T-SB-0075-13

TOYOTA Technical Service Bulletin

MIL "ON" DTC P0401

Figure 1.

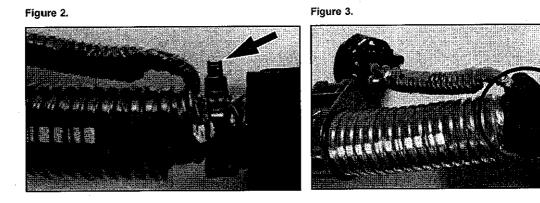
- 3. Modify the wire harness using the following procedure.
 - A. Remove the vinyl tape wrapped around the main harness and the EGR harness.

B. Wrap the exposed zip tie 7 - 8 times with the heat-resistant vinyl tape.
